Date: 06.12.10
Subject: Fuel Cam Follower

Engine type: **M 43 C**
Page 1 of 2

M 43 C Fuel Cam Follower

Figure 1

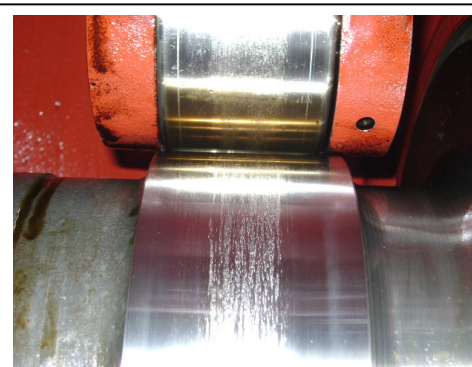
1. **Visual inspection** of fuel cam and roller for unusual marks: This does not refer to the circumferential marks described in Service Info 03-05 "Running Patterns of Rollers and Cams". Please check the roller for grinding marks and/or material transfer from the roller to the fuel cam (see Figure 1).

- any unusual marks during the visual inspection of the fuel cam and the roller (1)
- or a clearance (2) in excess of 0.8 mm when carrying out the measurement
- or a difference in excess of 0.2 mm between the values on both sides when measuring the clearance (2)
- or if you can see the bush when carrying out visual inspection (3)

please contact your MaK agency as soon as possible in order to have the findings confirmed and a repair carried out if required. If this cannot be done within a short timeframe, the engine can continue to operate. In this case the affected assembly should be inspected in each port and the trend should be documented. Latest, however, if material crumbling occurs on roller, bush or cam, the assembly needs to be promptly replaced.

Figure 2

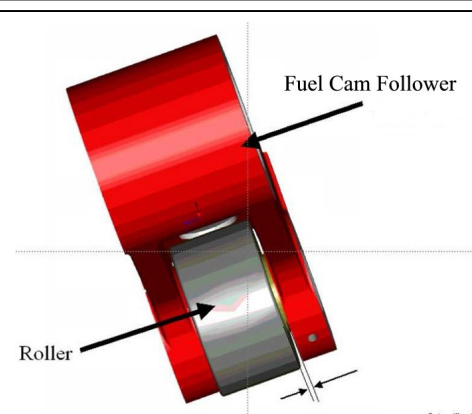
3. **Visual inspection** to determine if the bronze-coloured bush of the roller is visible (see Figure 2). If the roller is in proper condition, the bush should not be visible.
